Addendum #1

ITT 2025-18

**General Contractor Services for Daycare Addition project at
ÉEC Sainte-Marguerite-Bourgeoys, Brantford**

MECHANICAL ADDENDUM

M3.1

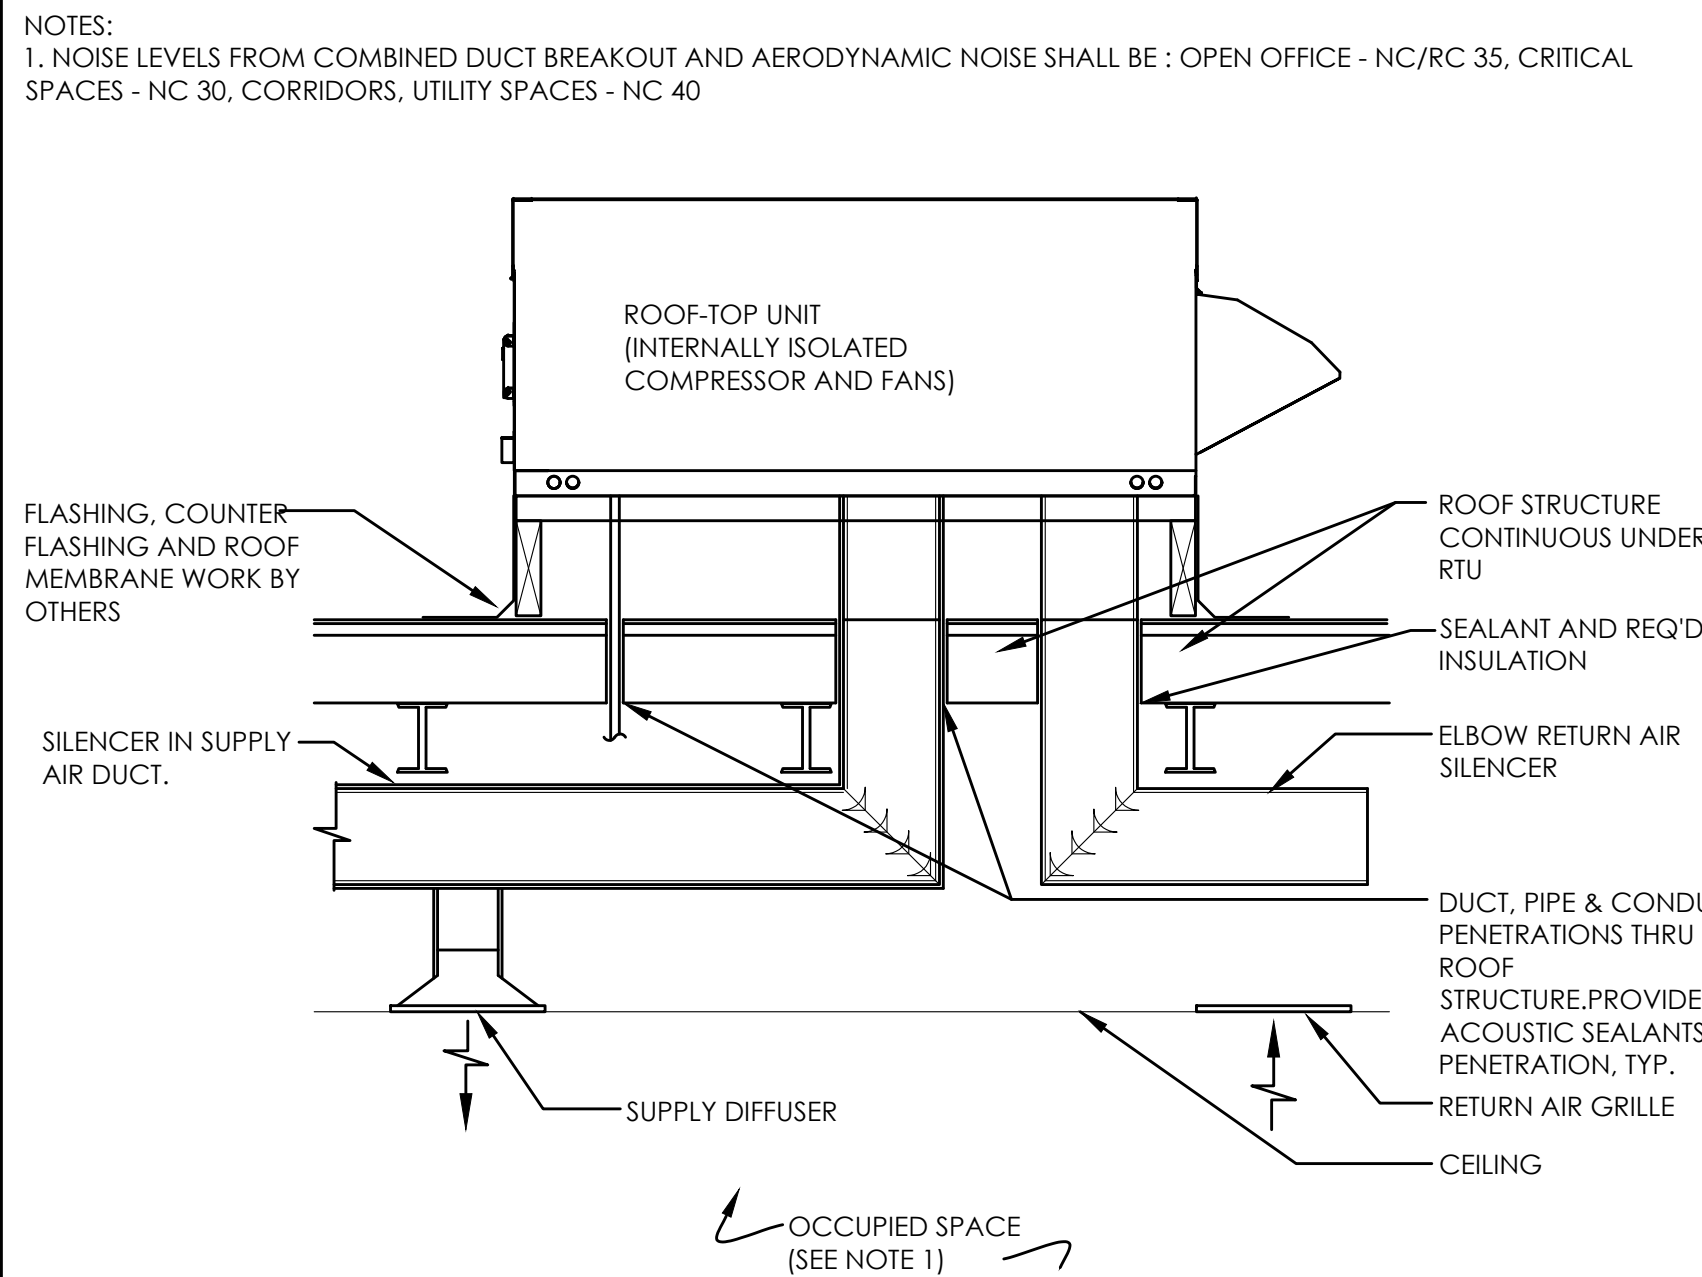
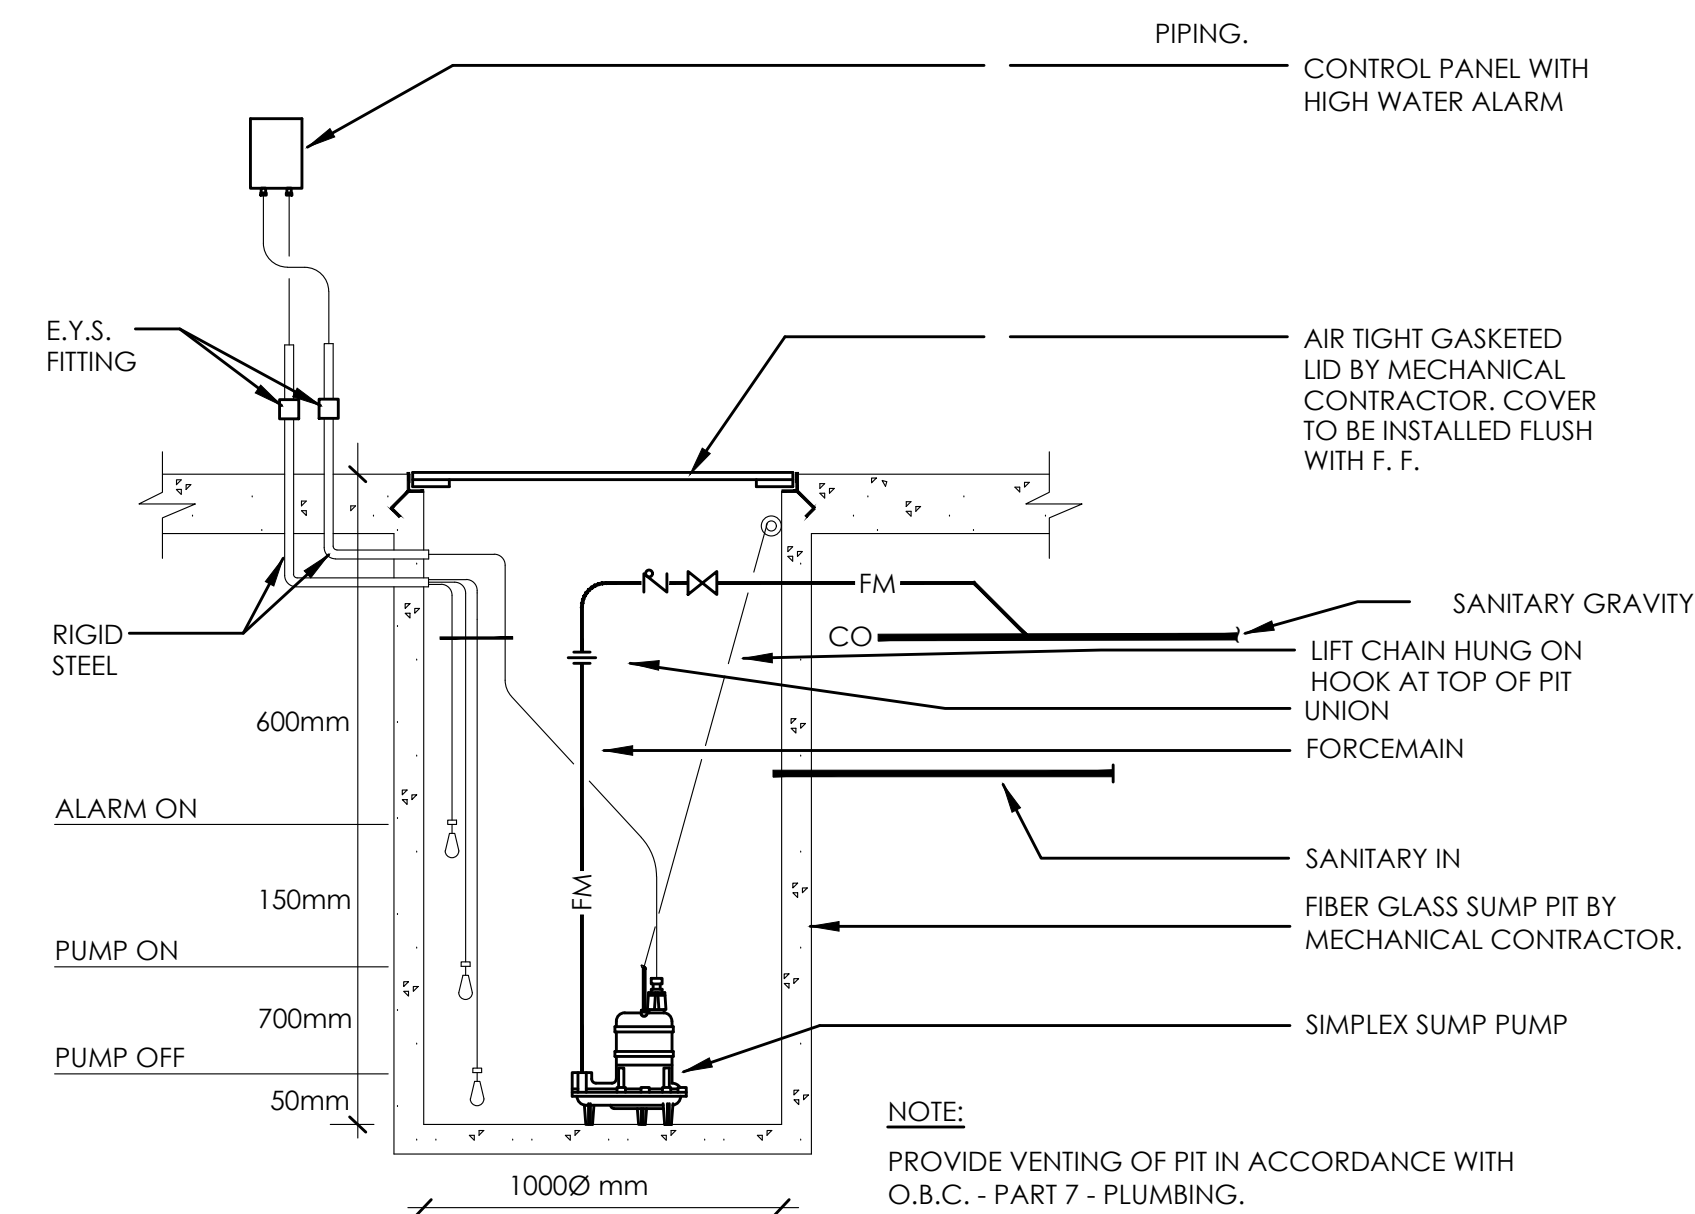
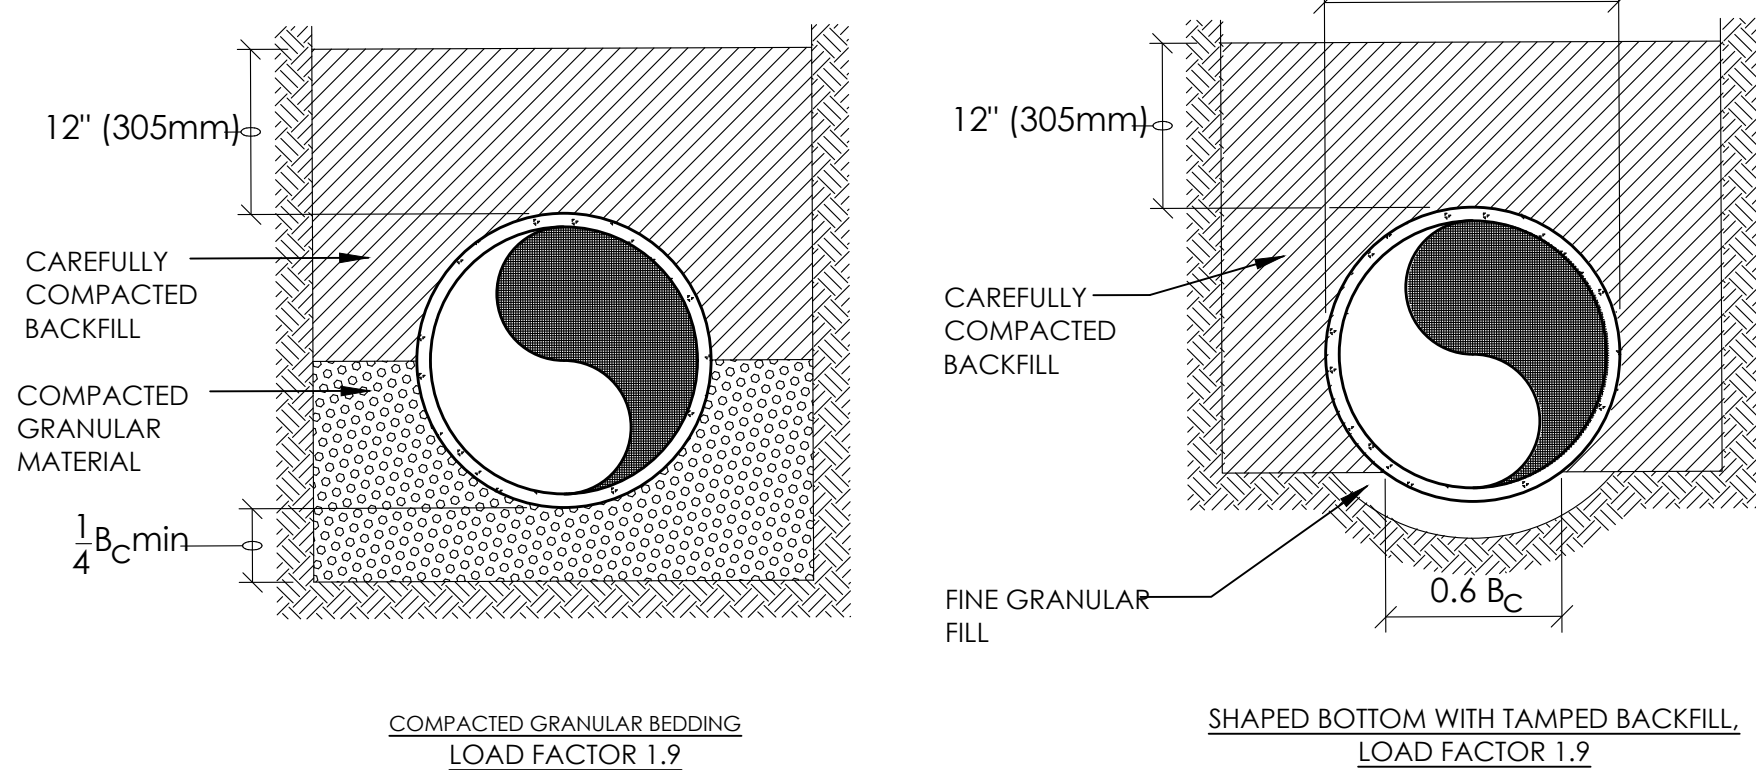
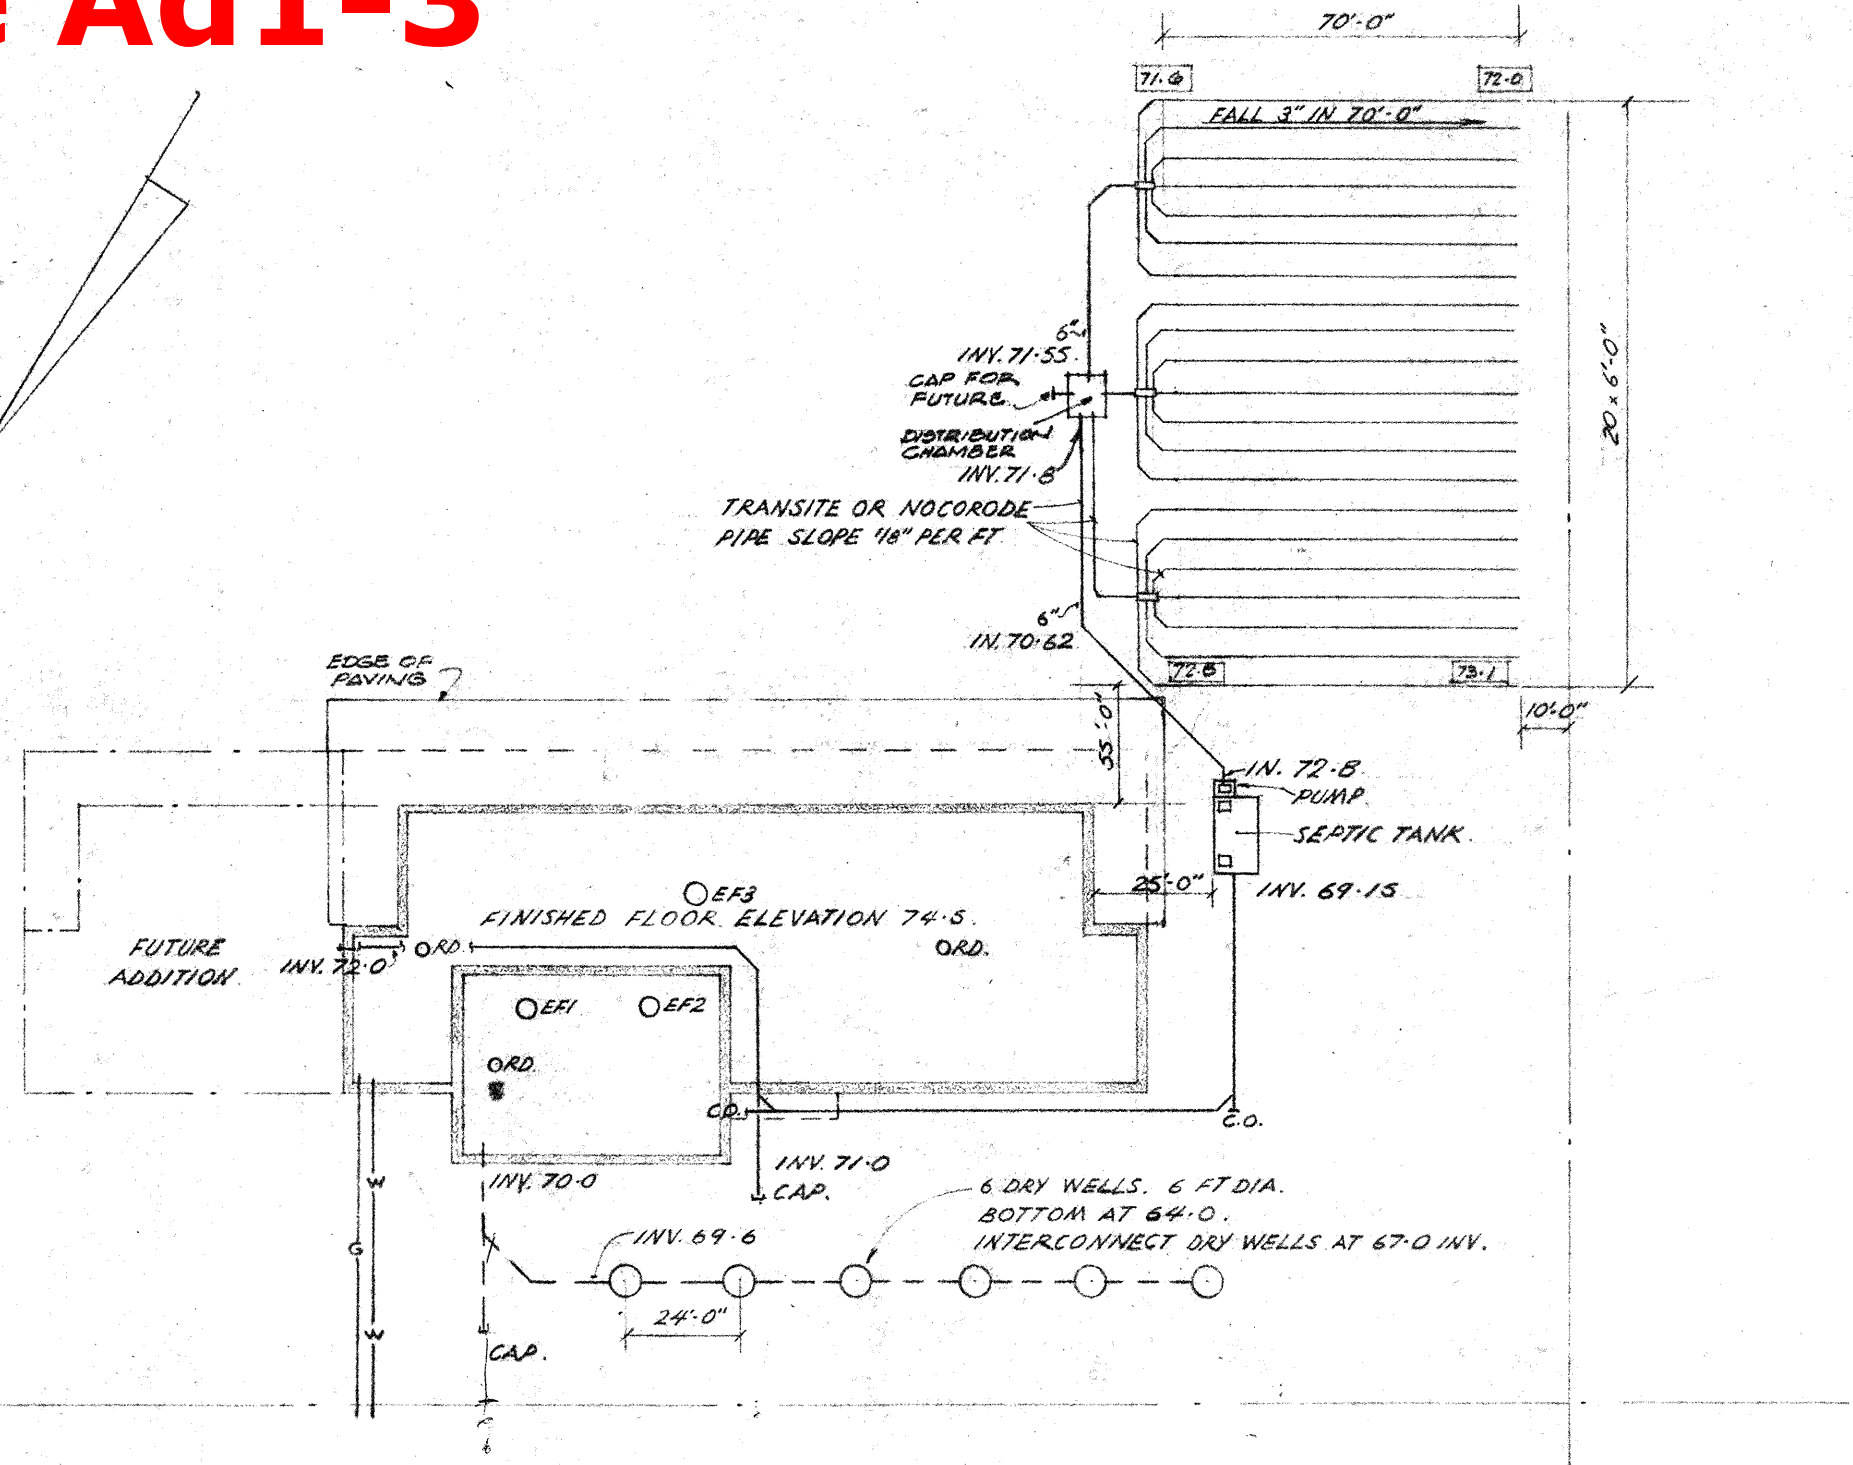
- .1 M3.1 Details and Schedule
 - .1 RTU schedule updated to match AAON RTU with power exhaust fan.
- .2 M3.4 Details and Schedule
 - .1 Control Schematics for RTU updated to reflect power exhaust fan.

Annexe Ad1-3

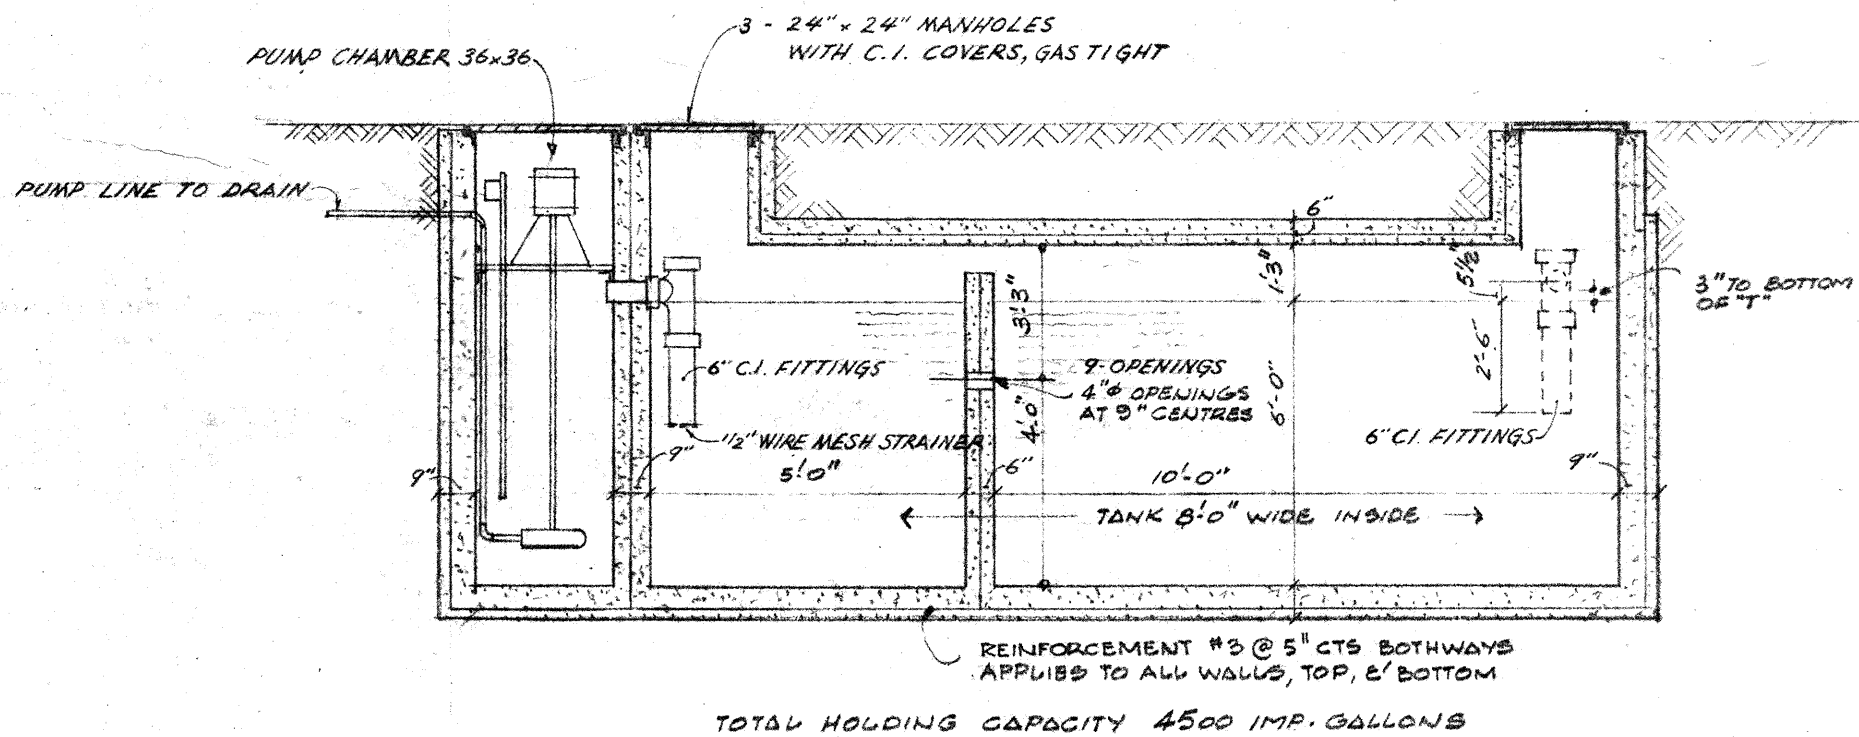
Question 4: Drawing C0.0, detail 3 states to remove remnants of the septic bed and dispose, please provide the thickness of this septic bed.

1.5. Drawings for installation of abandoned septic system. (annexe Ad1-3)

Answer 4: Please refer to the enclosed drawings for the installation of the abandoned septic system.
